Foxground and Berry bypass

Princes Highway upgrade

Submissions report

MAY 2013

Figure 2.8 Berry Equestrian Centre
Draft schematic plan – option 1

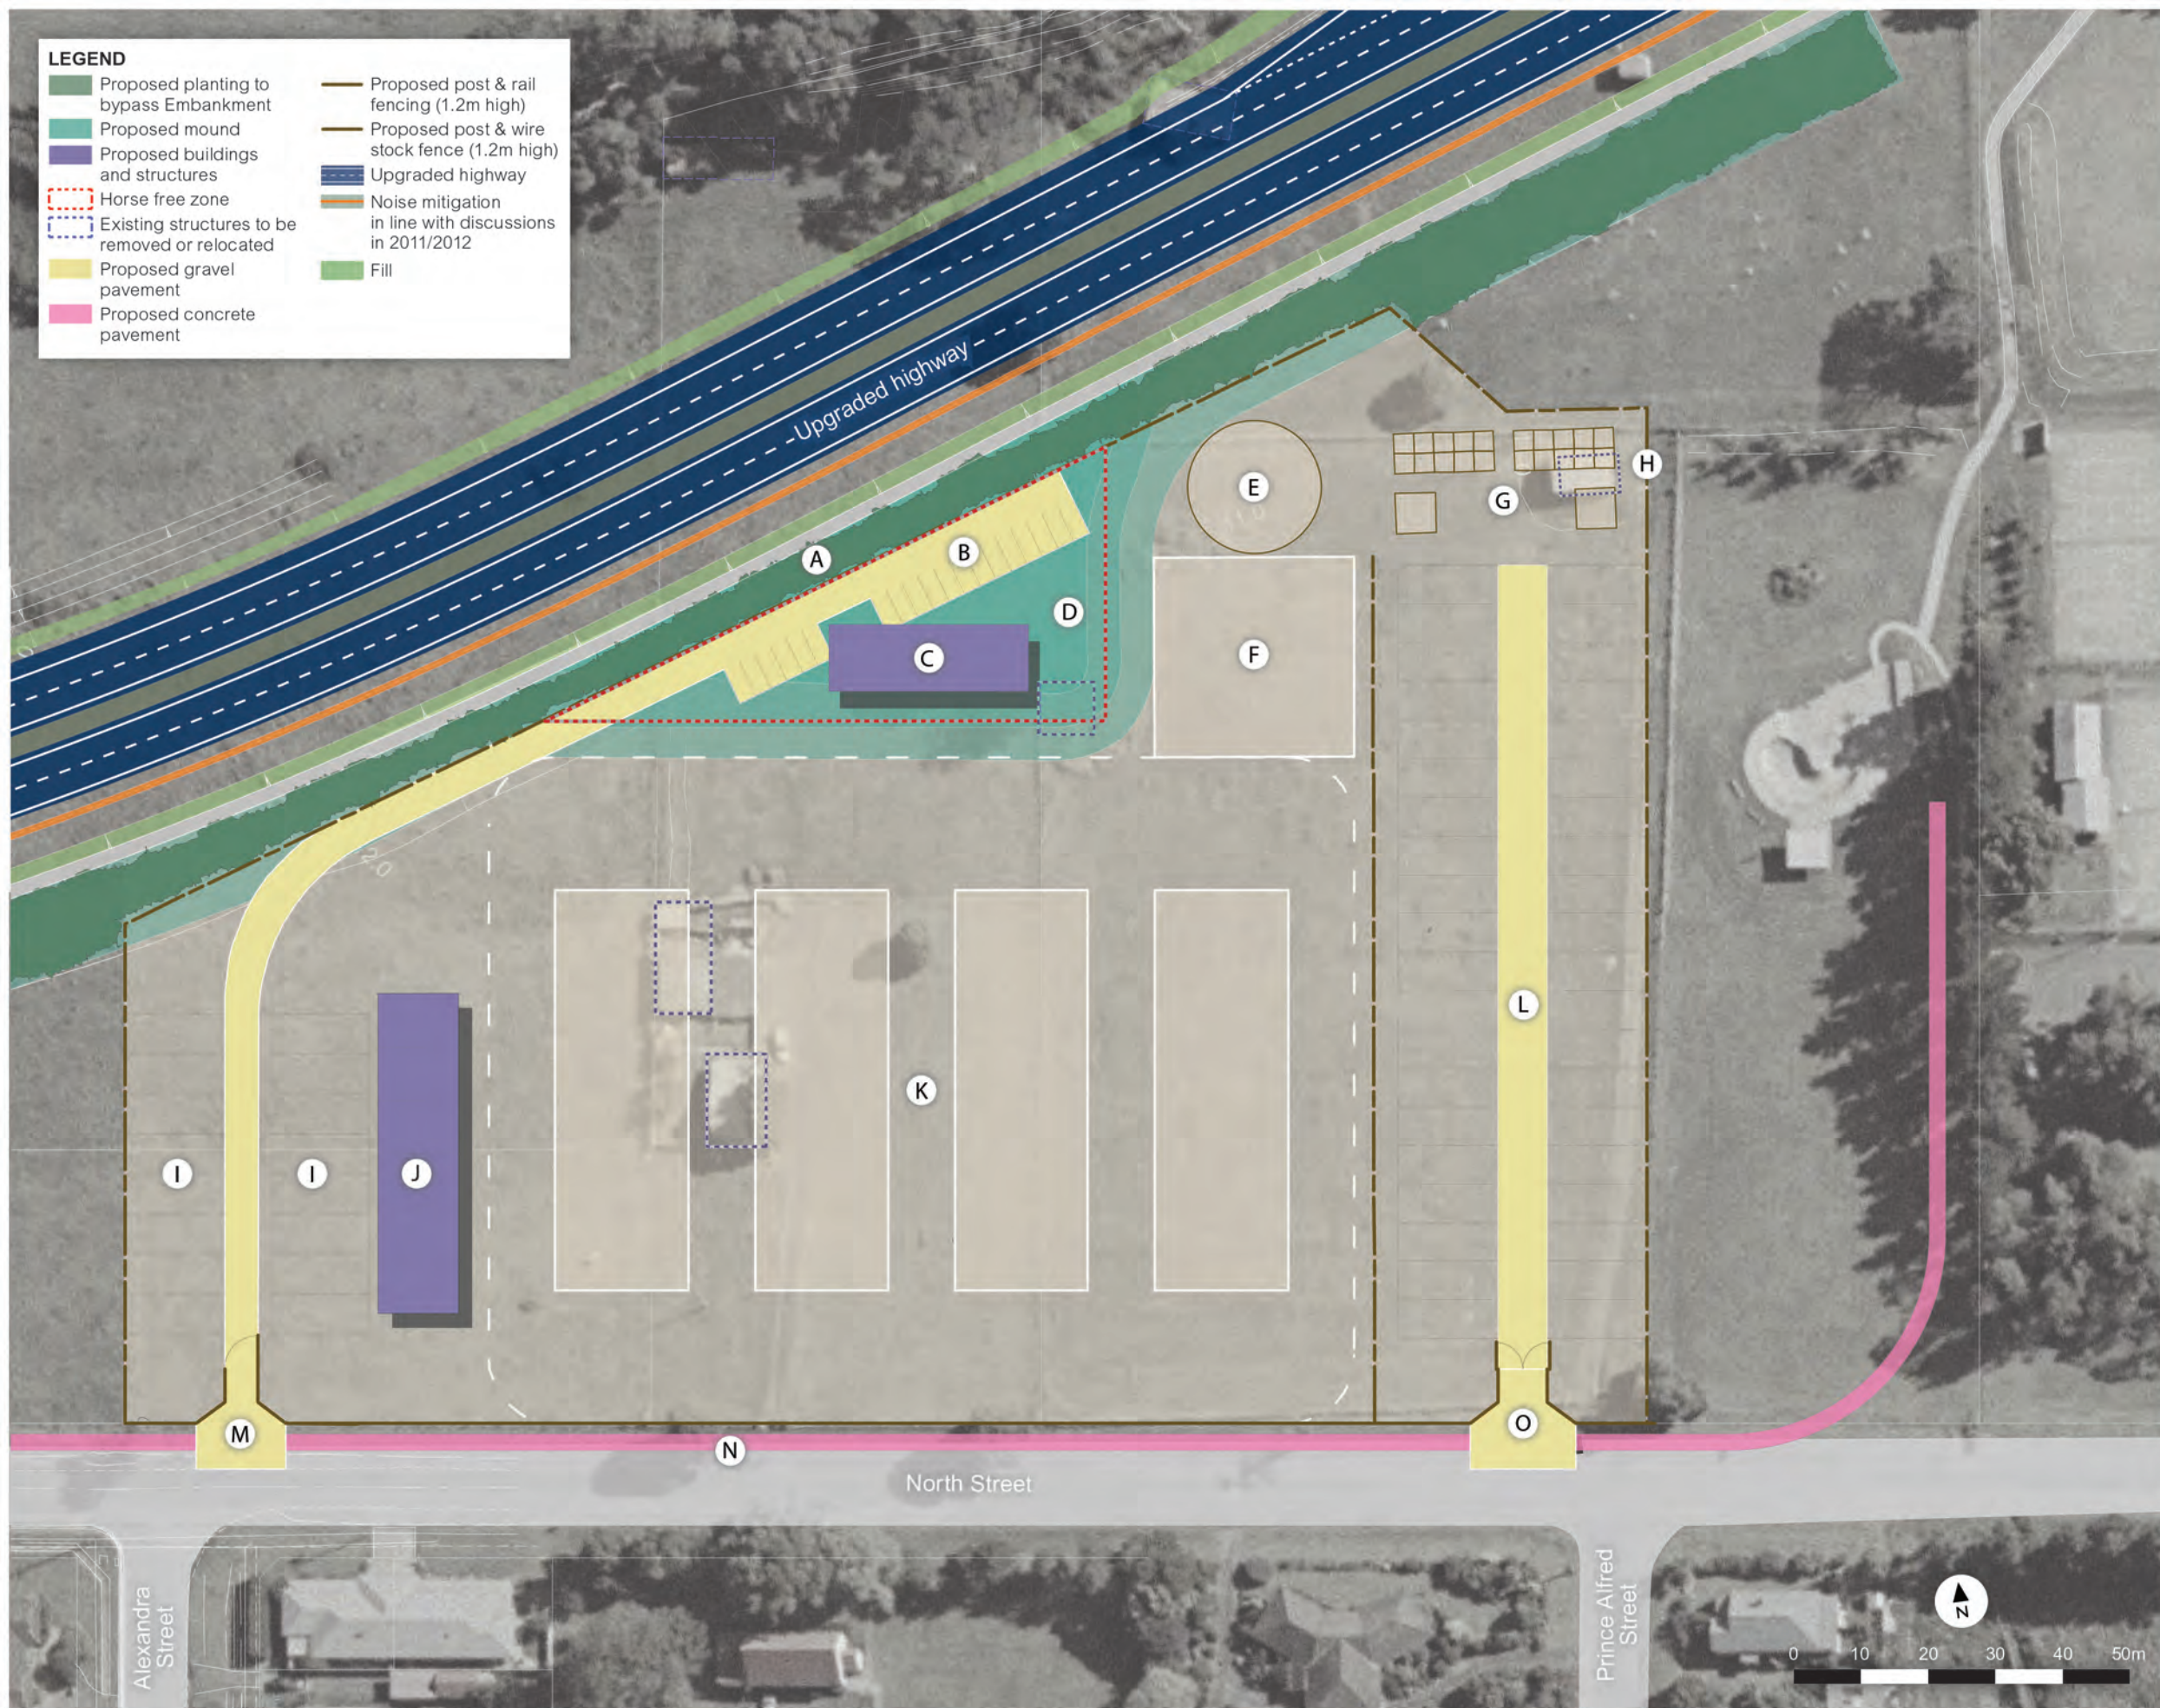
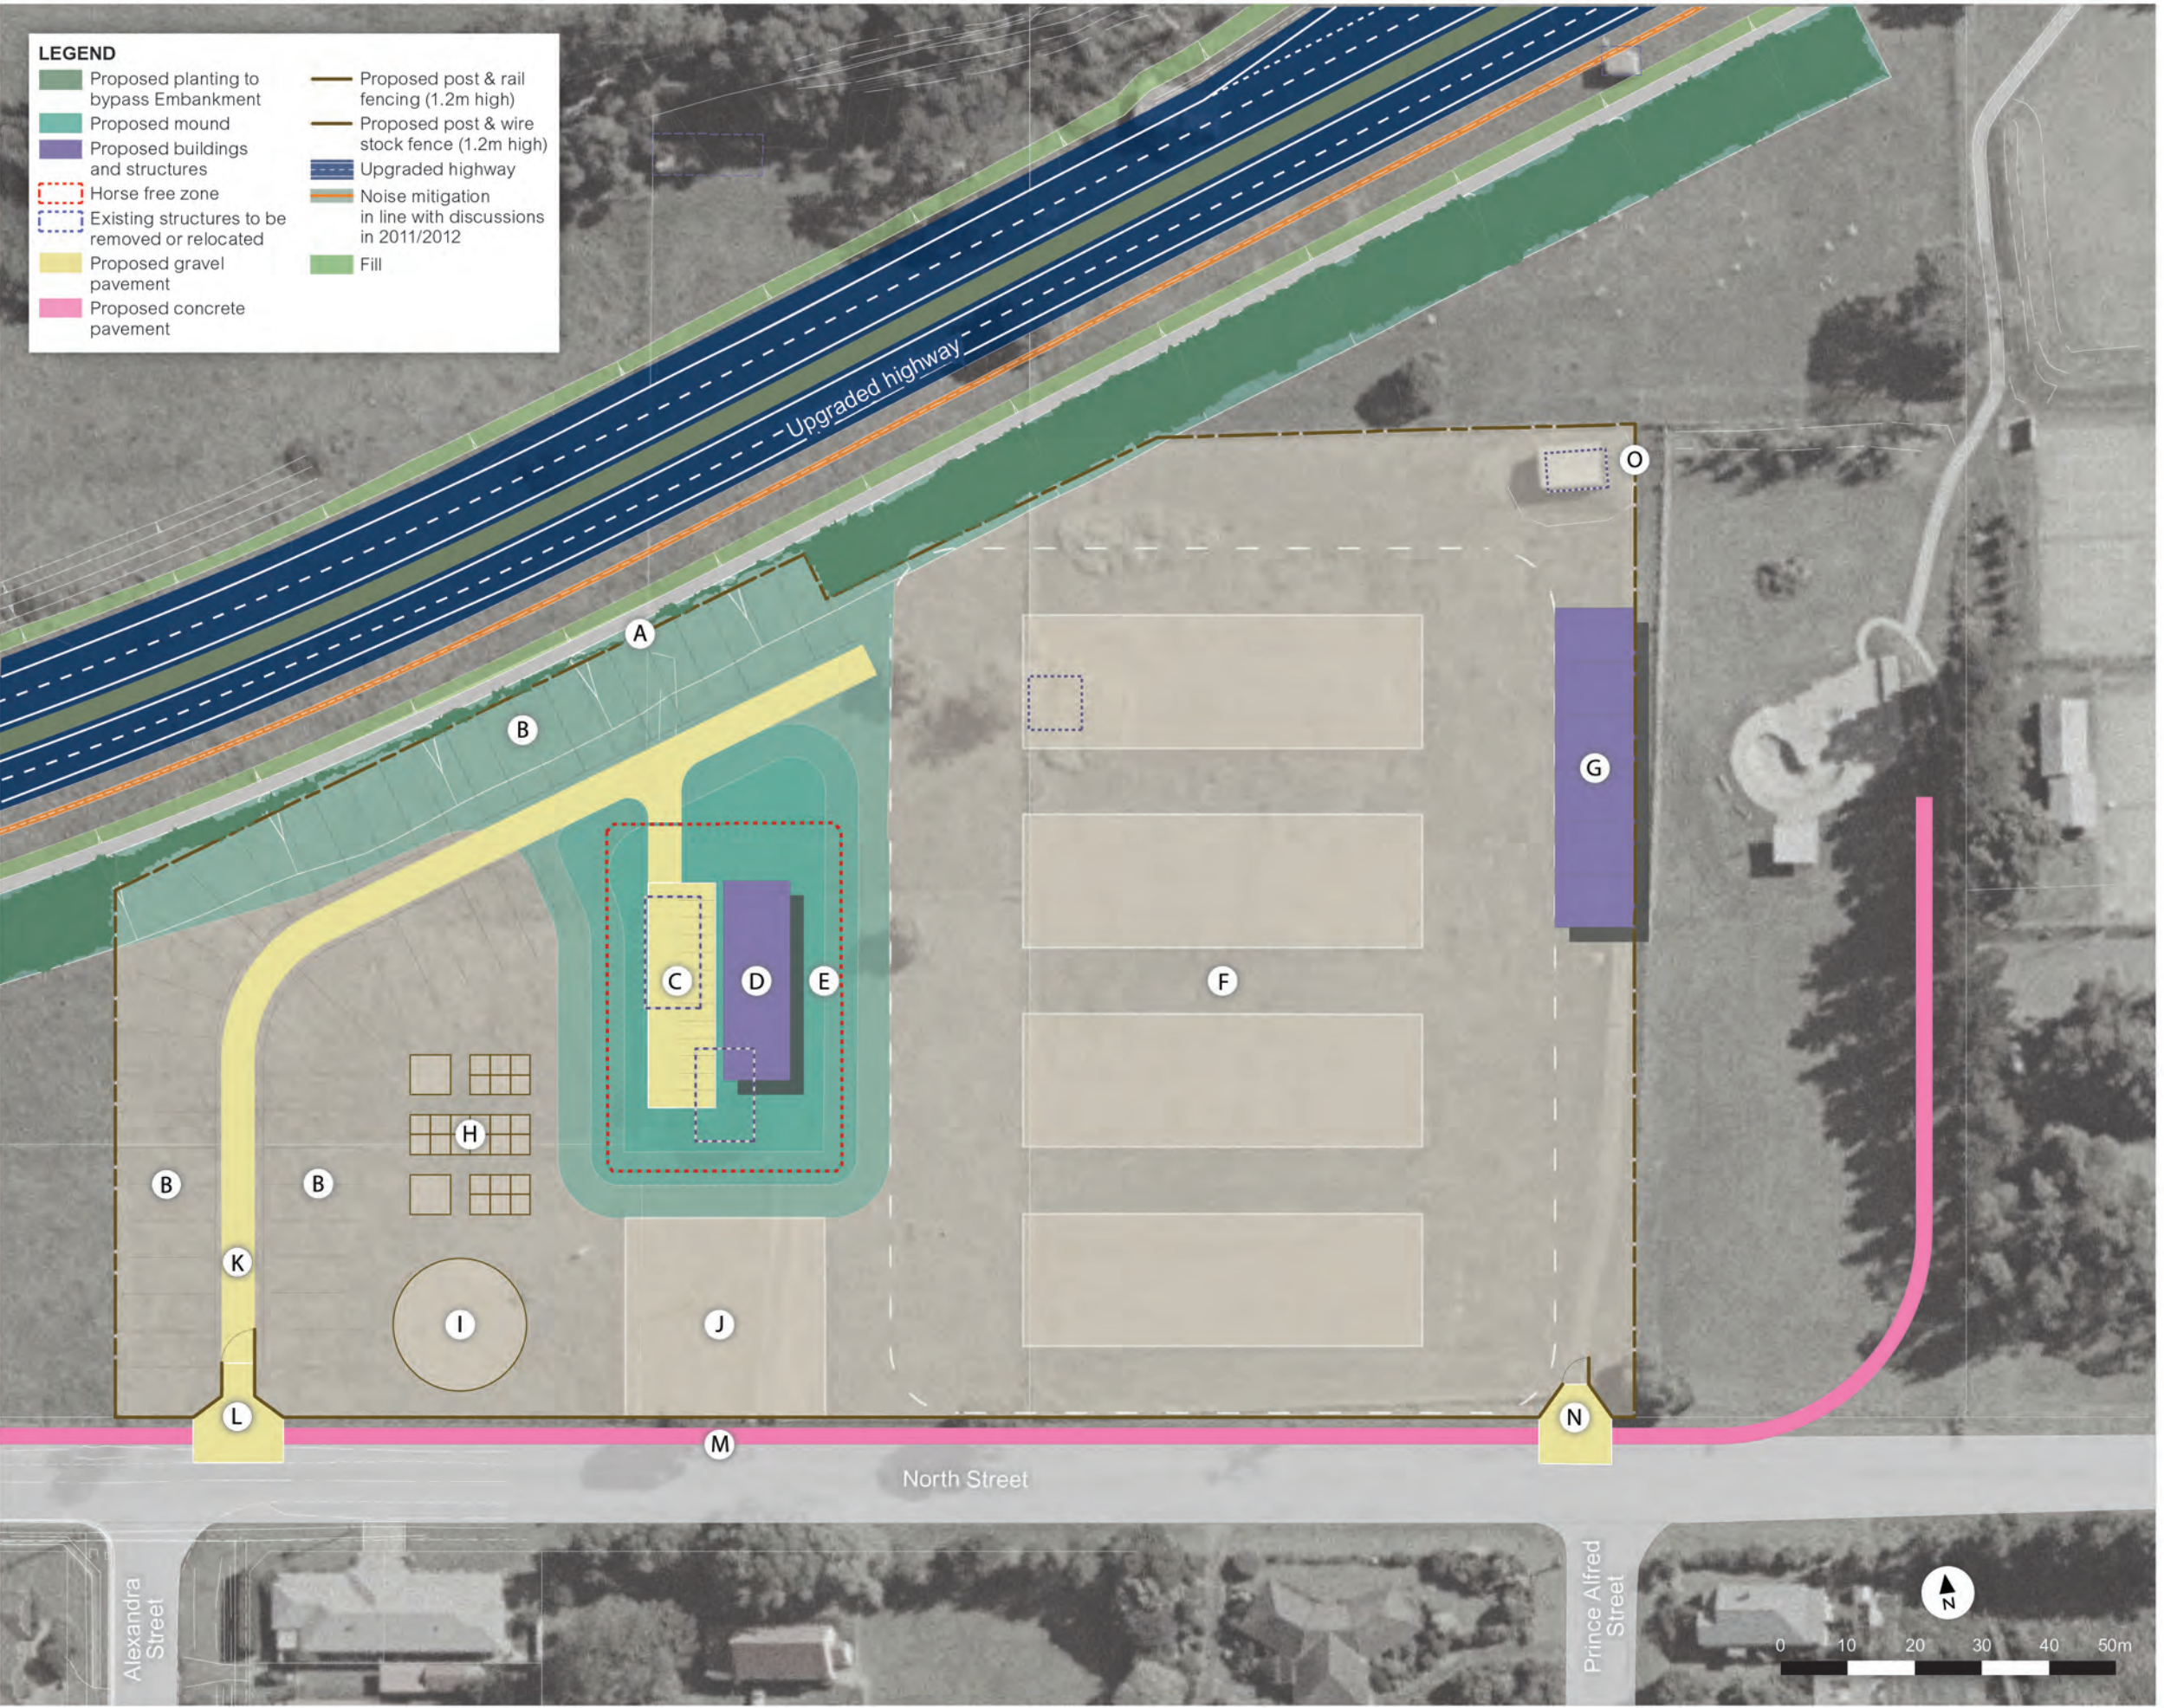
Respondents also raised concerns about the proximity of vehicles to the Berry Equestrian Centre and noise and other impacts of the highway on riders. Respondents were particularly concerned about noise during equestrian competitions. Proposed noise mitigation measures include a barrier between the western end of the bridge at Berry and Kangaroo Valley Road and low noise pavement along the length of the alignment (further details are provided in Section 7.2 of the environmental assessment). The barrier could take the form of a wall or embankment and would be located between the Berry Equestrian Centre and the project. It would provide separation of users of the Berry Equestrian Centre from the project.

Discussions would be undertaken between RMS, Shoalhaven City Council as the land owner and the Berry Equestrian Centre to establish a new configuration for the centre. RMS has agreed with Shoalhaven City Council that the club would be provided with an equivalent facility on a larger parcel of land than was suggested within the environmental assessment, to be consistent with the current size of the facility. Shoalhaven City Council has engaged an architect to prepare a concept plan in consultation with RMS and the Berry Equestrian Centre, as illustrated in **Figure 2.9**. Two concept plan options have been developed to respond to the issues described above. These indicative plans will form a basis for any future discussion about the site.

Figure 3.1 Property access at chainage 12260

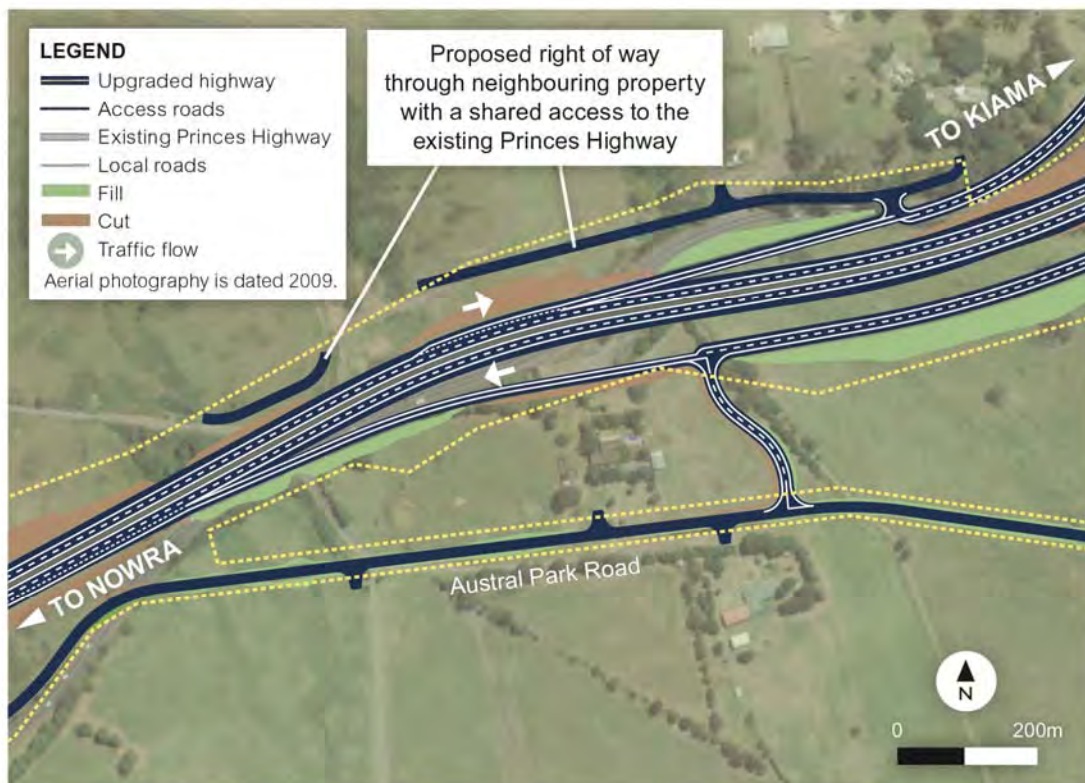
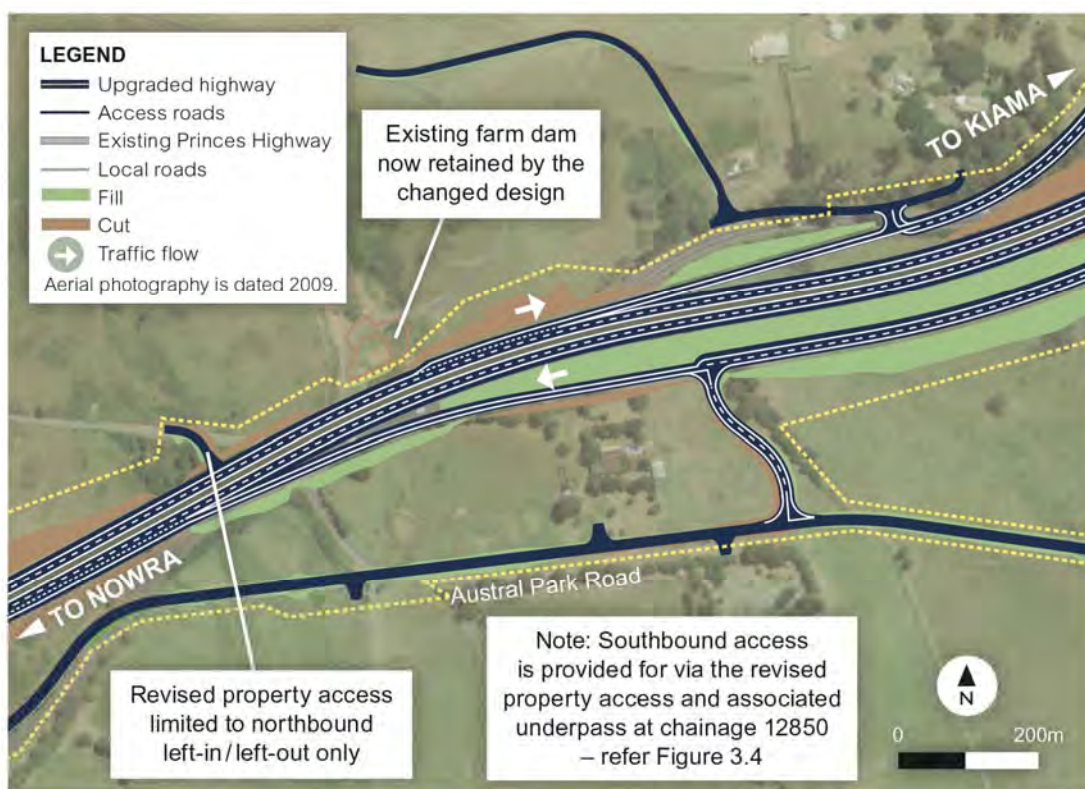
A property access arrangement as presented in the environmental assessment has been changed. Under the original design, property access was provided via a right of way to the existing highway at about Chainage 11900. The original access design is shown in **Figure 3.1**.

The proposed new access reduces land use impacts and acquisition on the neighbouring property and would be limited to left-in / left-out movements only. The new access would connect directly to the upgrade at about Chainage 12260. The proposed design is shown in **Figure 3.2**.
